# Technical note

<b>Project:</b>	Bakerloo Line Extension	<b>To:</b>	Chris Porter, for TfL comment
<b>Subject:</b>	New Cross Gate Station Option 3B Review	<b>From:</b>	Neil Baker
<b>Date:</b>	31 Aug 2018	<b>cc:</b>	-

This Technical Note provides an appraisal by Atkins of the Option 3B concept design, on behalf of Transport for London (TfL), as part of an ongoing engagement process with Sainsbury's Mount Anvil (S/MA).

Option 3 - Proposed Platform Level Plan

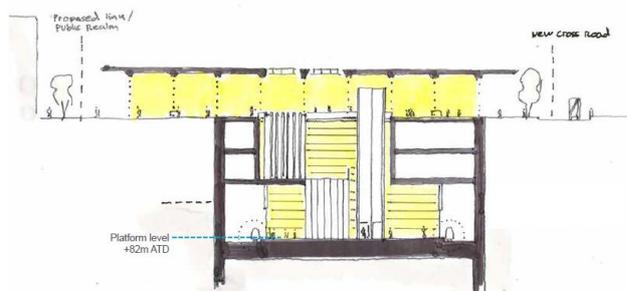
The station arrangement is comprised of an asymmetric deep station box, assumed to be approximately 50m wide by 60m long, incorporating enlarged stub platform tunnels at its lowest level and a series of connecting passageways that form circulation routes outside of the station box. Further accommodation and circulation space is included at ground level, above and beyond the extent of the station box.

The station arrangement is geometrically complex and is likely to require meticulous construction planning to mitigate the risk (and NR-percieved risks) of adverse construction impacts on adjacent operational interests.

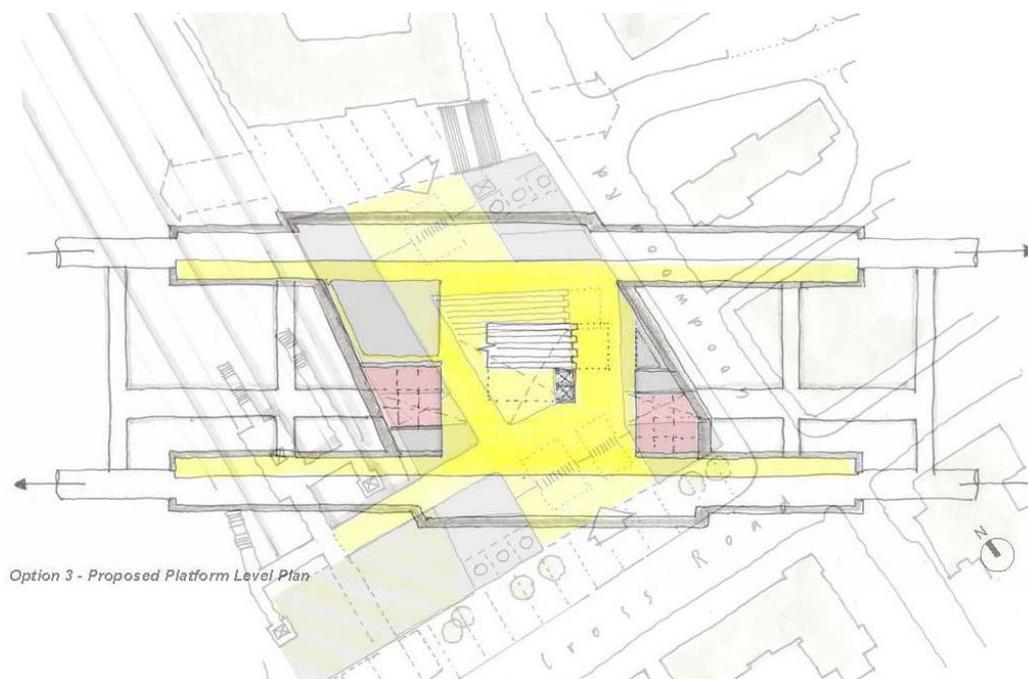
The illustration below provides an overlay of the two Option 3B scaled plans, provided by S/MA. The station box appears to extend beyond the site boundary, encroaching on Network Rail property and the paved areas of Goodwood Road and New Cross Road. It is considered that the box would need to decrease in length and width to allow it to be constructed in a feasible manner. The reduction in box size would likely mean that there would be insufficient residual space for passenger circulation.

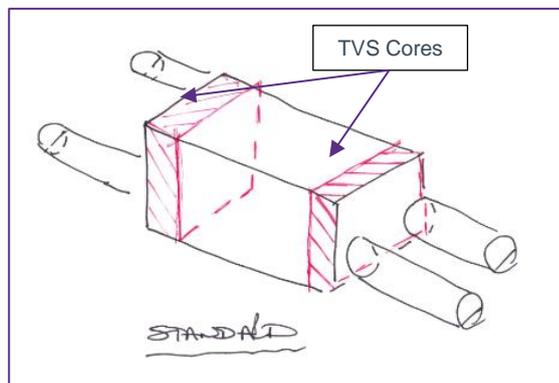
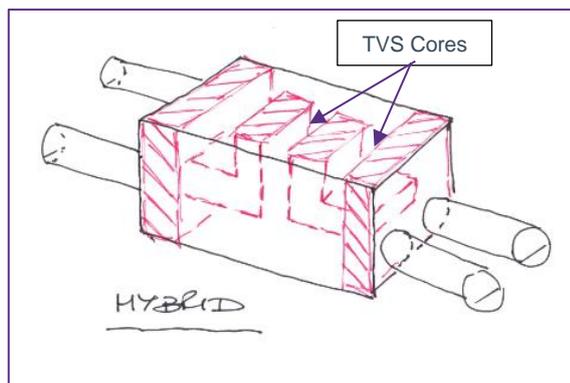
We have the following observations on this hybrid arrangement:

- The need for TVS connections within the station box at track level beyond the platform zone: the hybrid option does not appear to offer any savings in overall station length at that level;

- Relocating the TVS equipment rooms and the significant size ducts and adits that serve them from track level to surface at the ends of the station box to a centralized location, as well as the impact on space planning, is not demonstrated within the sketch proposals made;

- Relocating the TVS vertical equipment cores higher within the station box, itself, in a more central location and the impact on the overall station height and the accommodation of the vertical equipment, coupled with the respective discharge/louvre arrangements at surface level, or higher, is not demonstrated;

- The air paths, as can be seen due to additional bends, will add airway losses to a comparably sized standard arrangement. This may impact draught relief performance and require fans for forced ventilation scenarios to have increased motor sizes, resulting in greater energy consumption;

Option 3 - Proposed Platform Level Plan

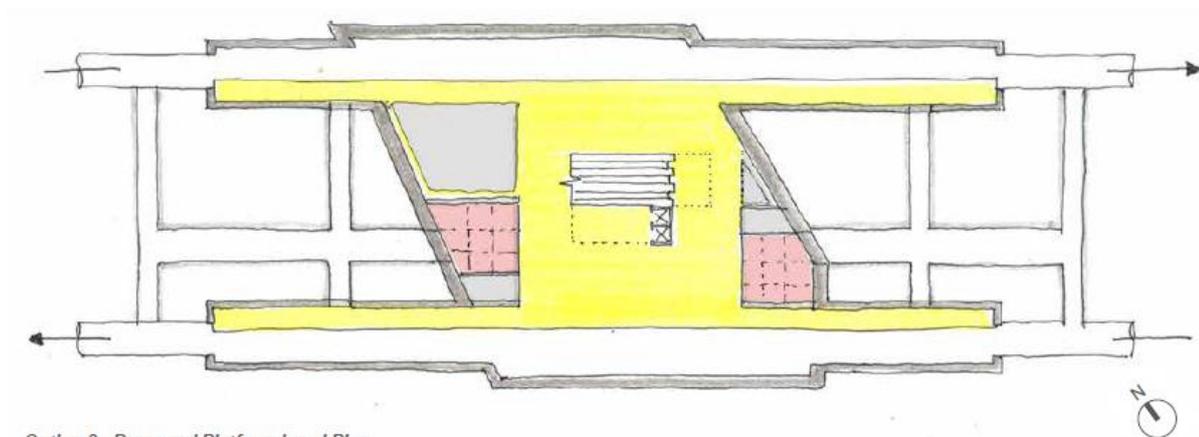
This type of arrangement would appear to have the potential to be compliant with LUL standard S1371, on the basis that the multiple exits should (if wide enough) be able to accommodate a platform clearance time of <4 minutes and, provided that there are no 'dead ends' > 20 m the platform escape configuration, may be compliant. It is less certain that the < 6 minutes to reach a place of relative safety requirement would be achieved, though, if strategically-placed fire and smoke resisting doorsets can be accommodated, this may deliver a compliant solution.

The alternative would be to provide dedicated escape shafts from the platform ends, but from the sketches showing the configuration at the surface, it is not possible to see how these could be straightforwardly accommodated.

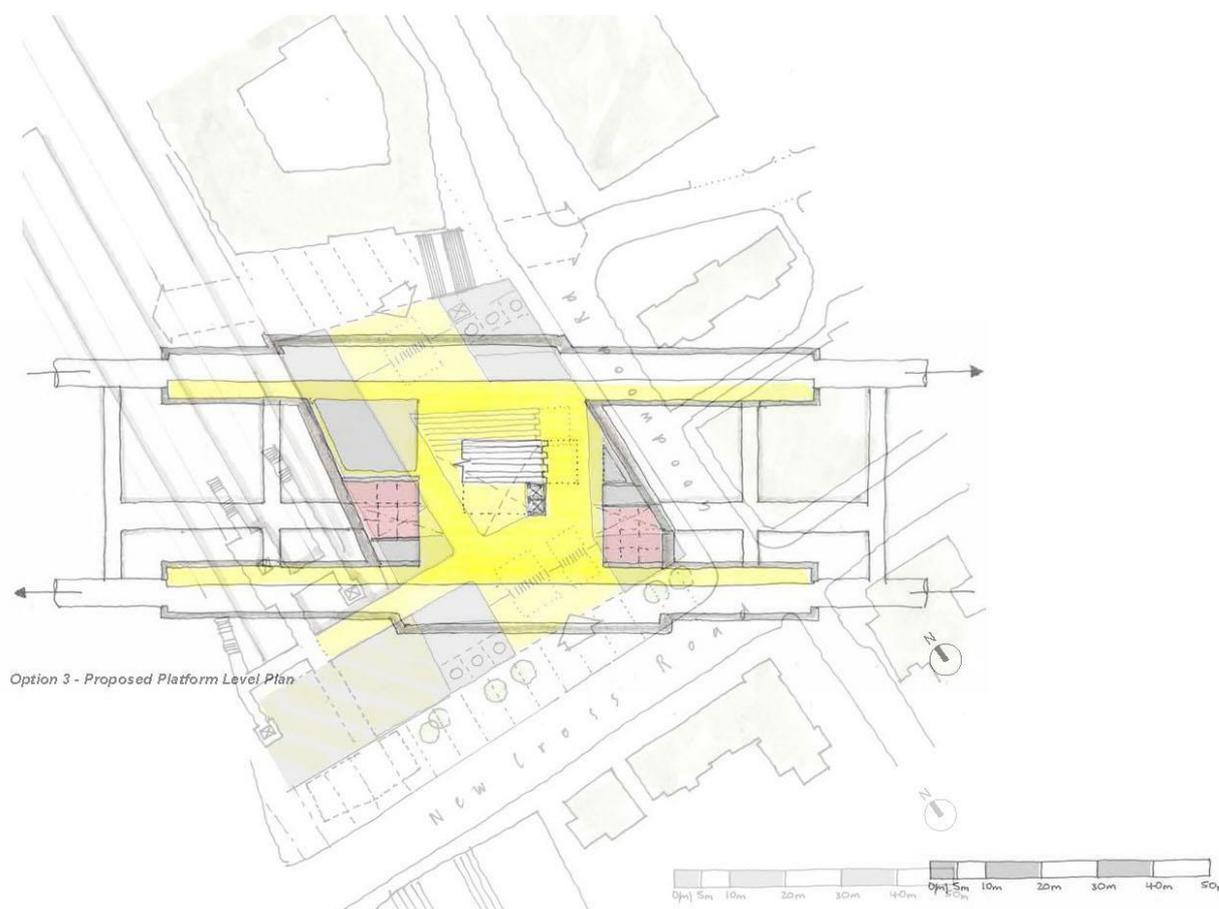
The station box is of similar dimensions to the footprint of the site, possibly extending beyond the footprint in the corners. Pending further design development, it is highly likely that services relocation within the pavement will be required, to ensure there are no clashes during piling, which will result in additional cost and additional delay to starting the box construction.

The construction of the station box will likely need to employ a top-down methodology, given the physical site constraints. This is not a challenge, in itself, but will mean that any level of maintenance on the TBM, above the most minor of activities, will not be possible at New Cross Gate, resulting in 2.2km of running tunnel without surface-to-tunnel access for the TBMs.

From the sketches provided, it is understood that Option 3B has a significant length of piling / diaphragm walling (approx. 60m) along the west length of the station box, on the boundary with NR. Construction in this location represents an increased level of risk to the NR asset.
